# TEXAS DEPARTMENT OF TRANSPORTATION

## Change Order Third Party Funding Notification Sheet

CCSJ: 3510-04-019CO #: 18Project: STP 2022 (936)MM, etc.District: HoustonHighway: SH 99Contractor: Webber, LLCCounty: Fort BendContract #: 351004019

DESCRIPTION: 102-IN DRILLED SHAFT DOWEL PACKAGE DELAY  
REASON: 1B - 1B-INCORRECT PS&E (CONSULTANT DESIGN)  
SECONDARY REASON(S):

SH 99  
BENT NO. 5

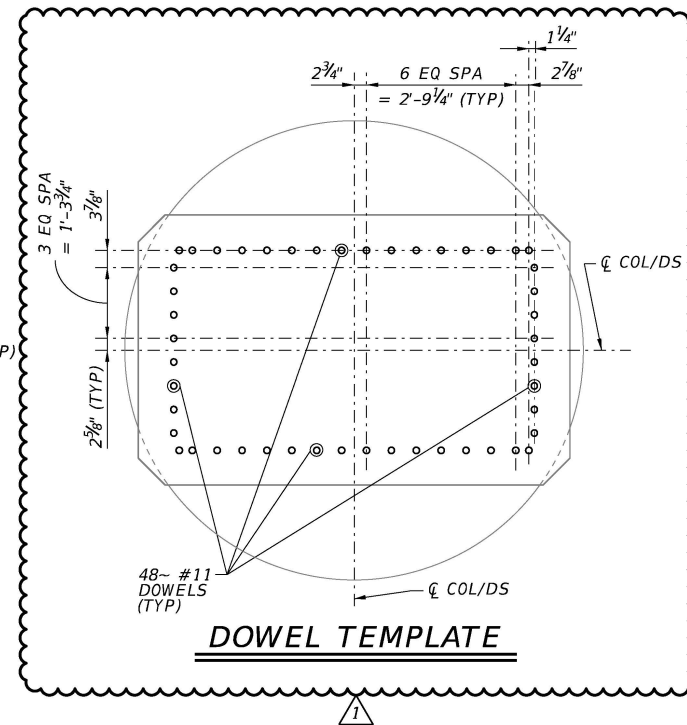
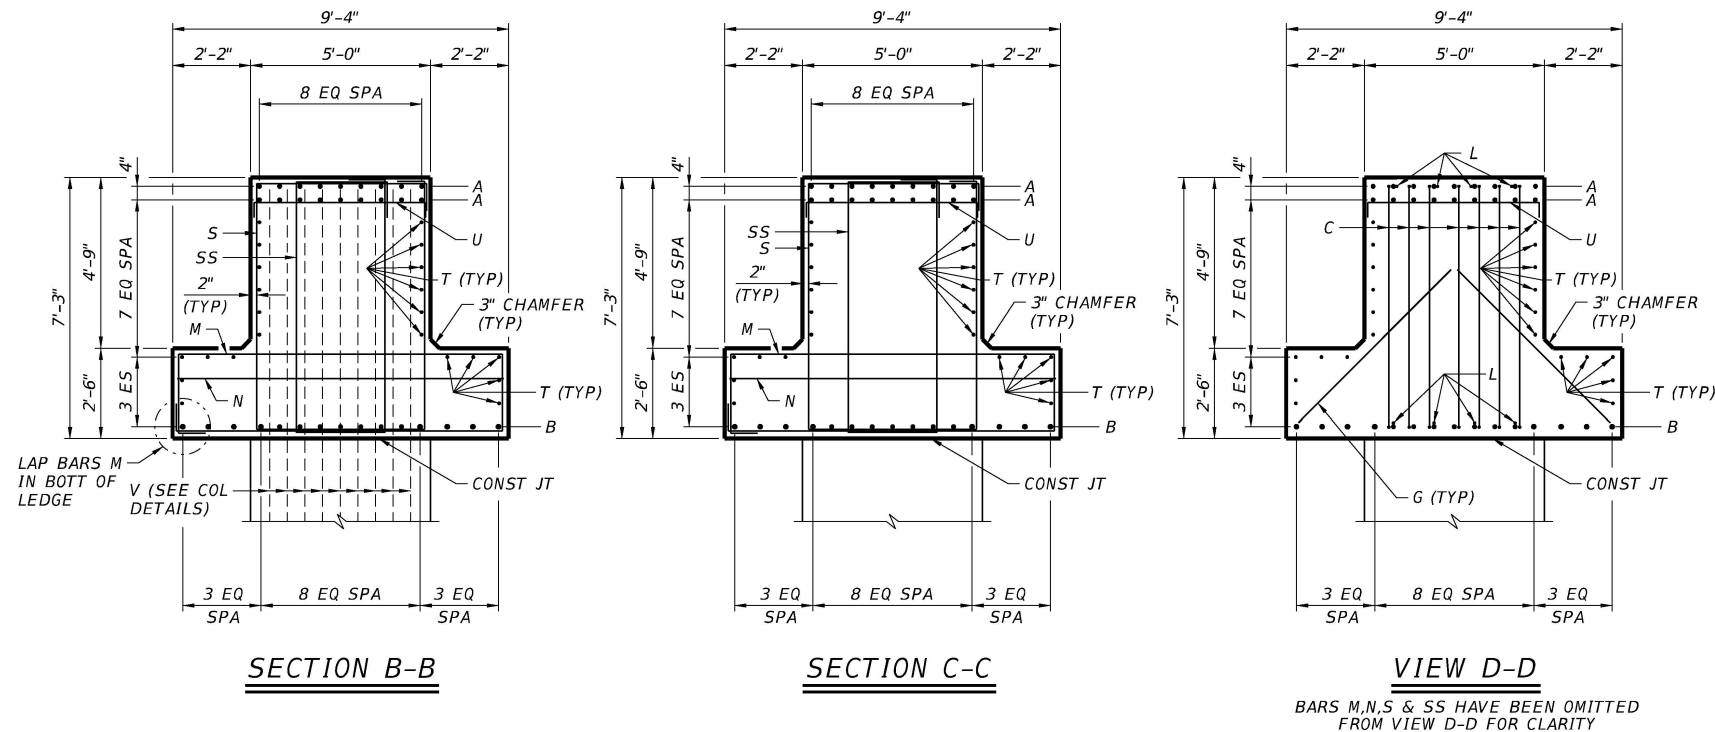
1	8/10/23	MODIFY DOWEL SPACING.	YFS
NO.	DATE	REVISION	APPROV.

SH 99  
BENT NO. 6

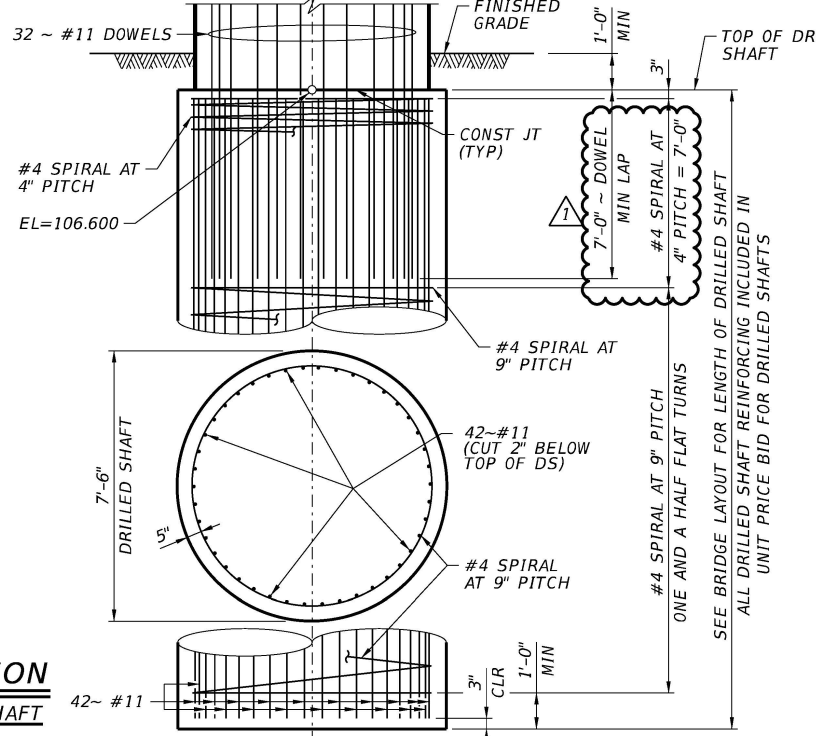
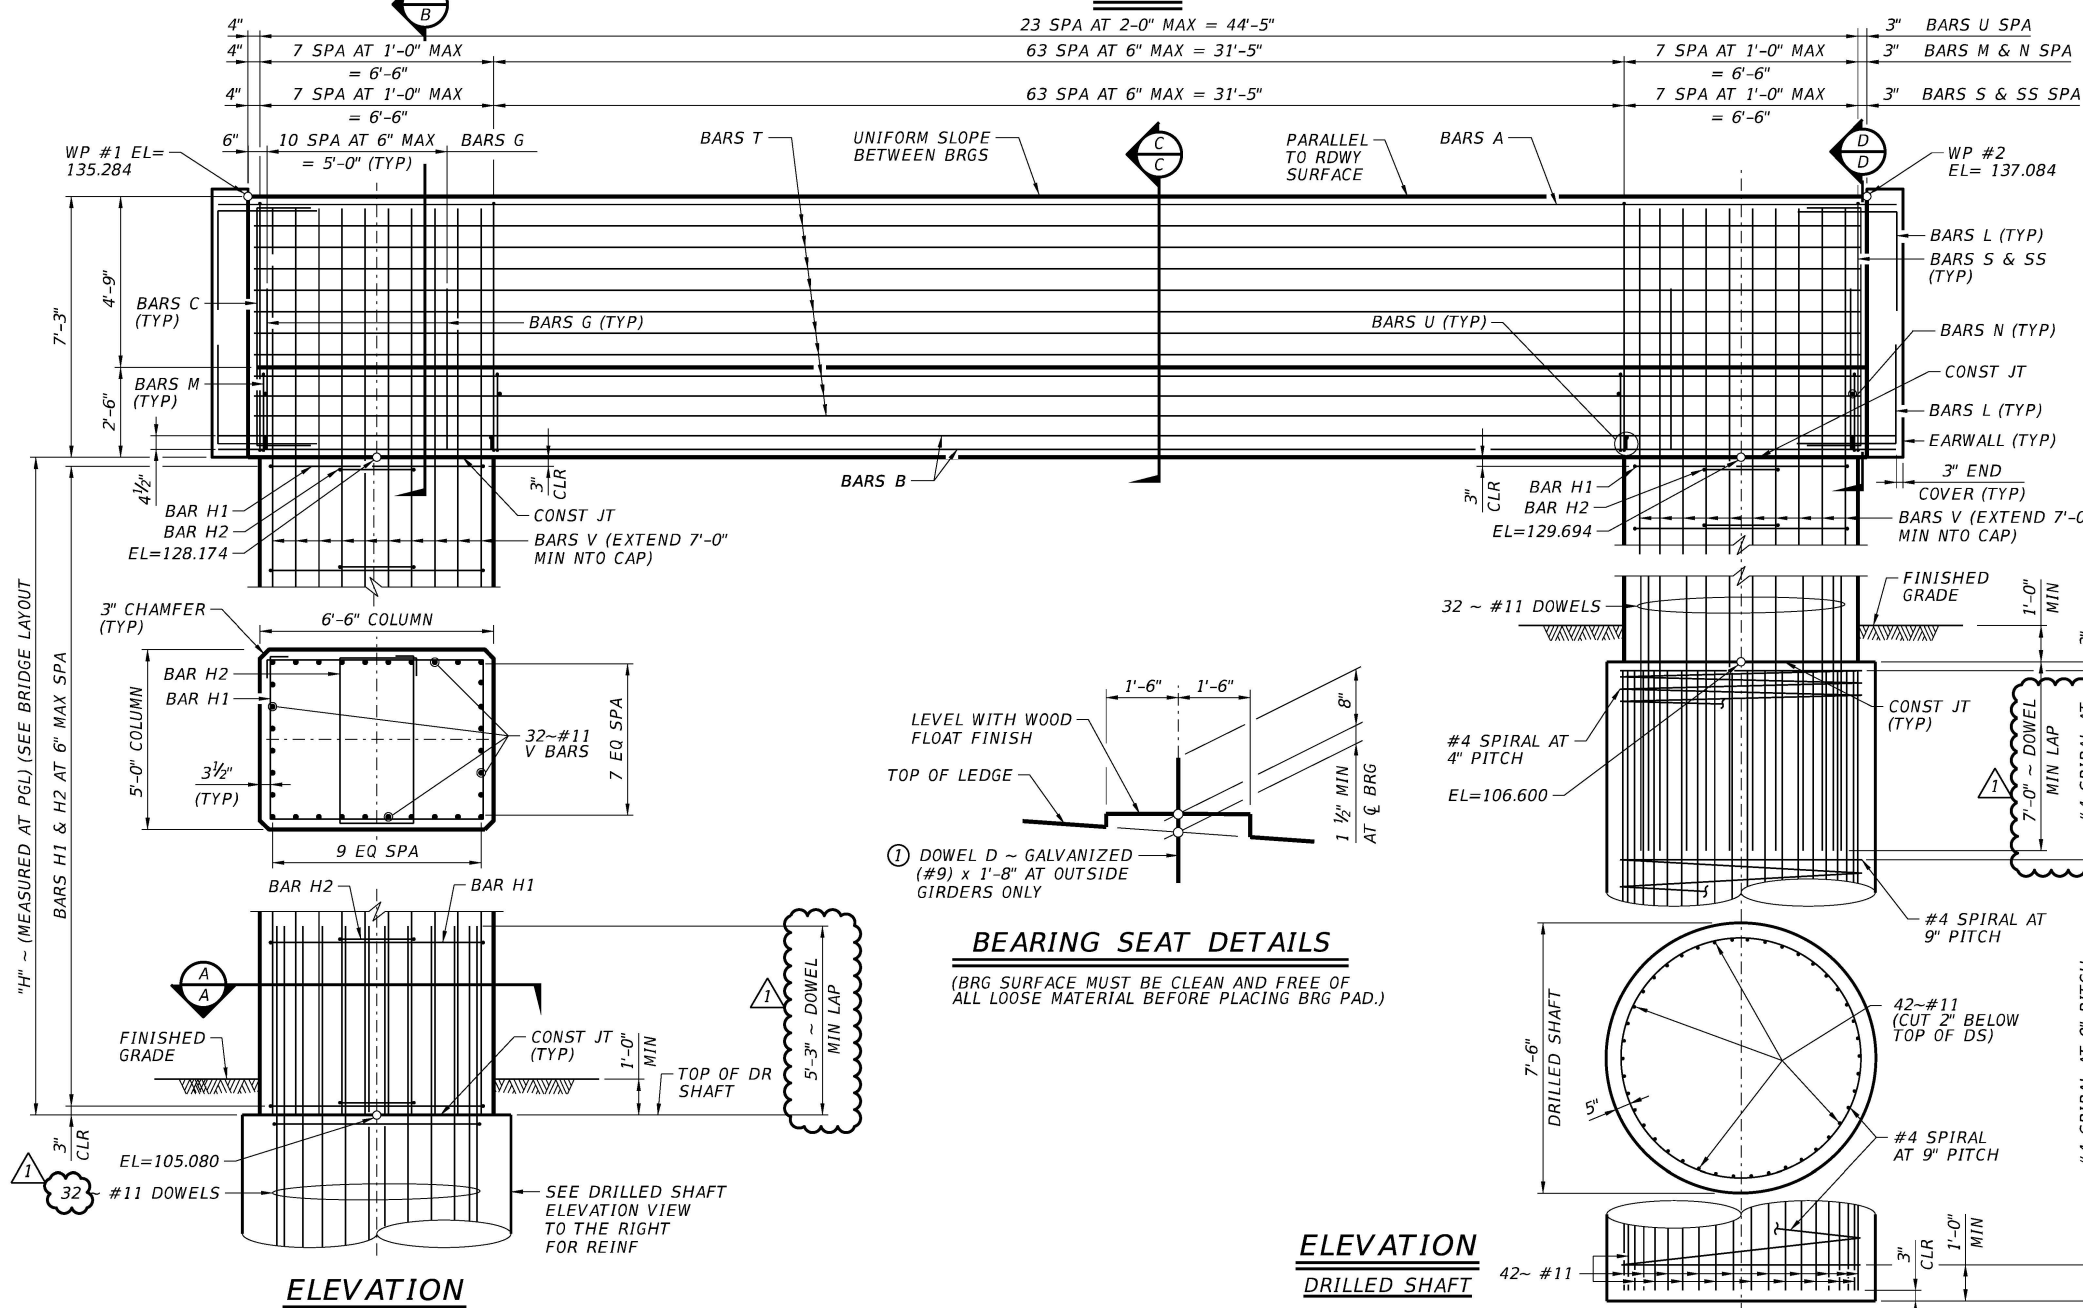
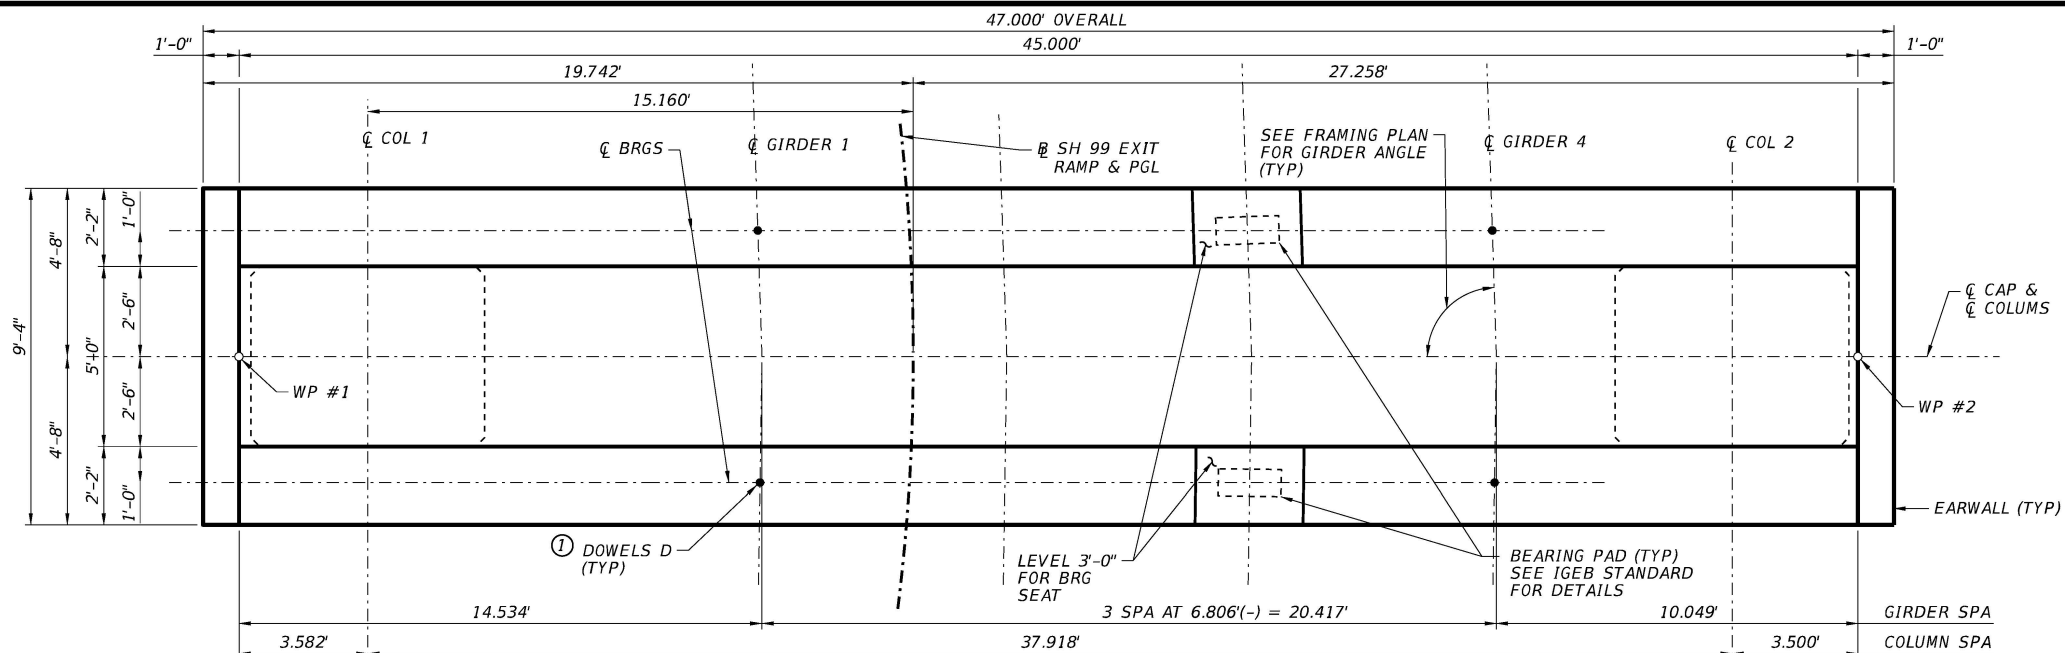
NO.	DATE	REVISION	APPROV.
1	8/10/23	MODIFY DOWEL LAP LENGTH AND NUMBER.	JFT

SH 99  
BENT NO. 7

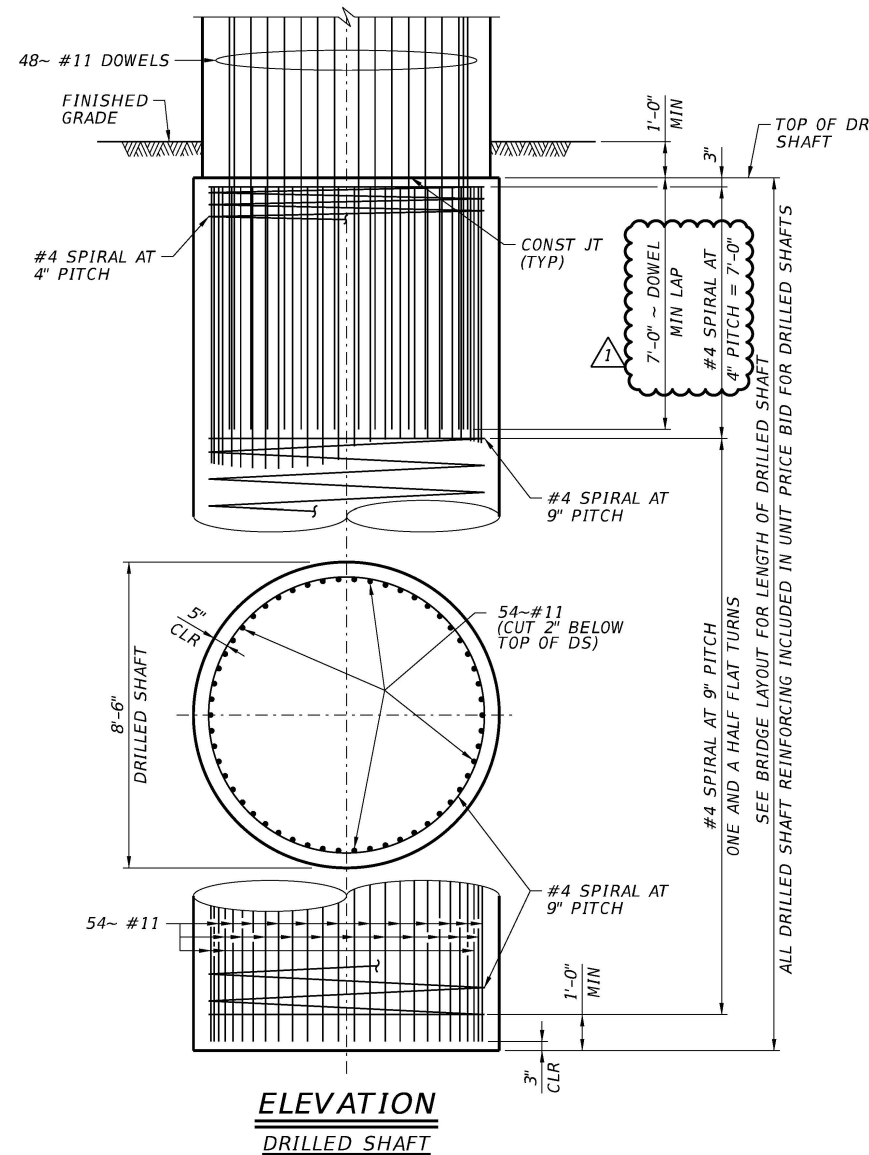
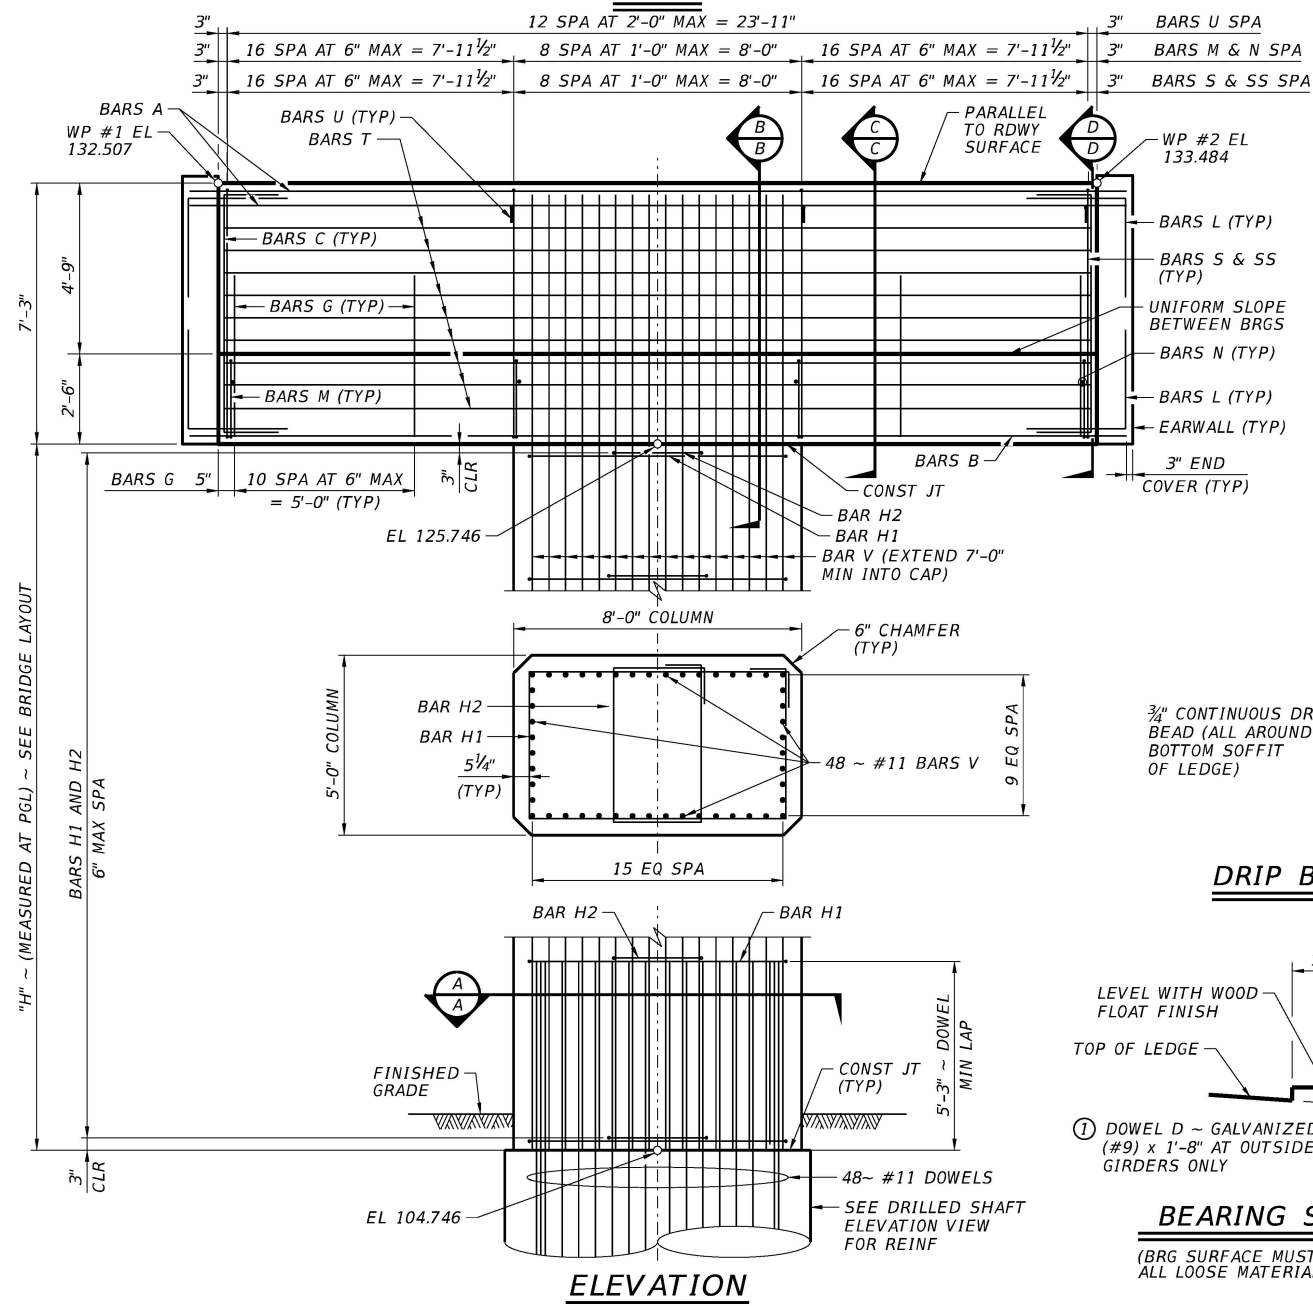
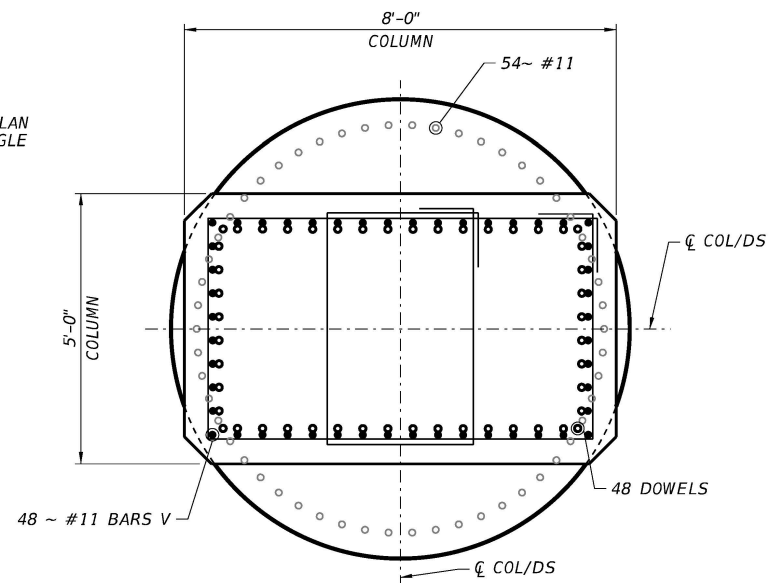
1	8/10/23	MODIFY DOWEL LAP LENGTH.	YFS
NO.	DATE	REVISION	APPROV.

BENT NO. 7

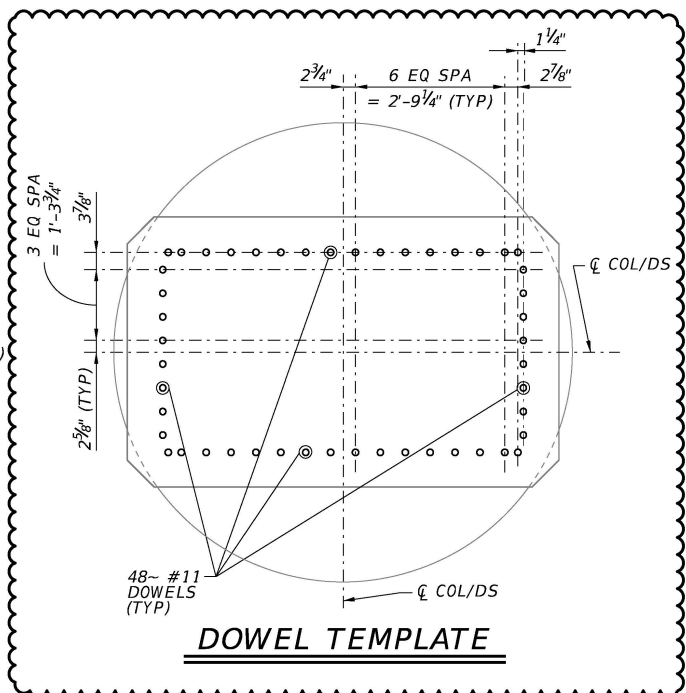
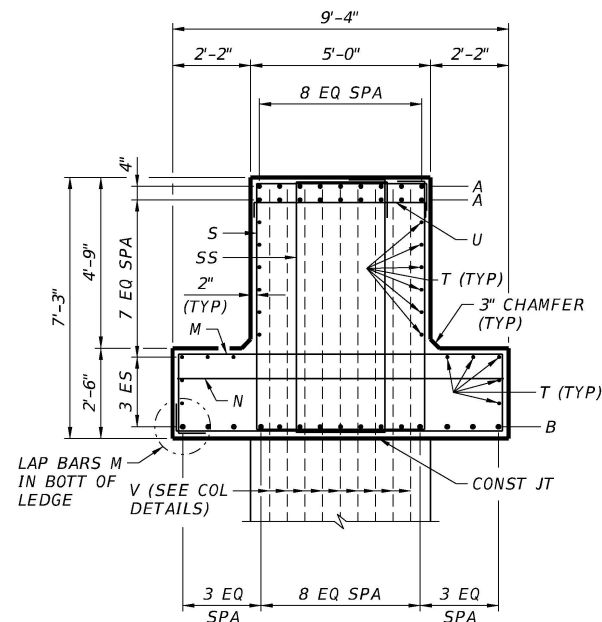
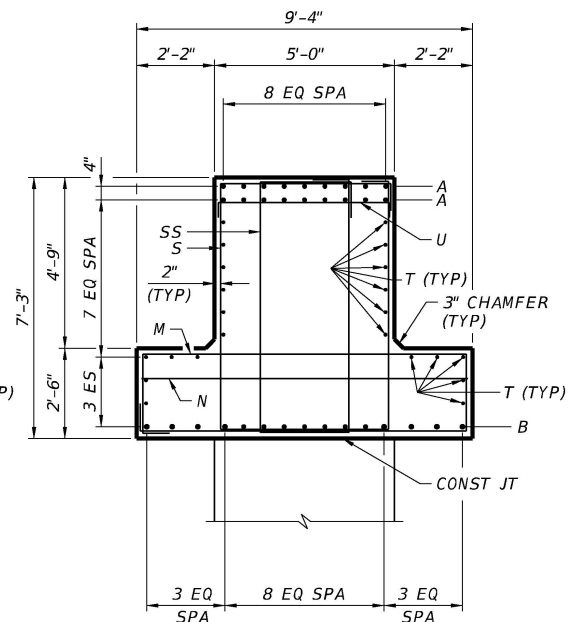
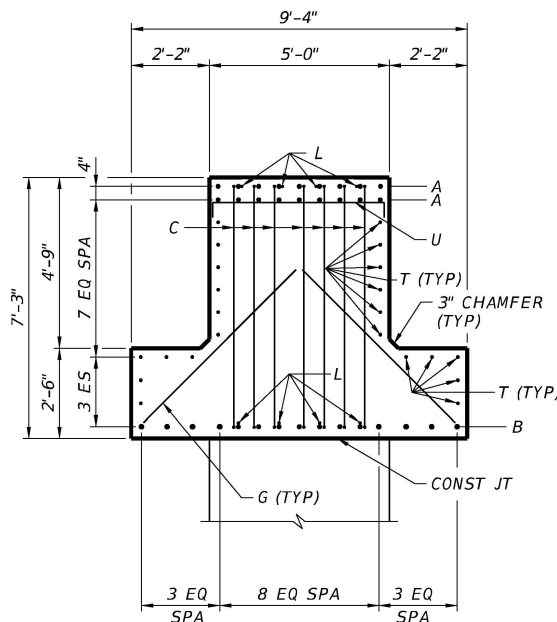
1	8/10/23	MODIFY DOWEL SPACING.	YFS
NO.	DATE	REVISION	APPROV.
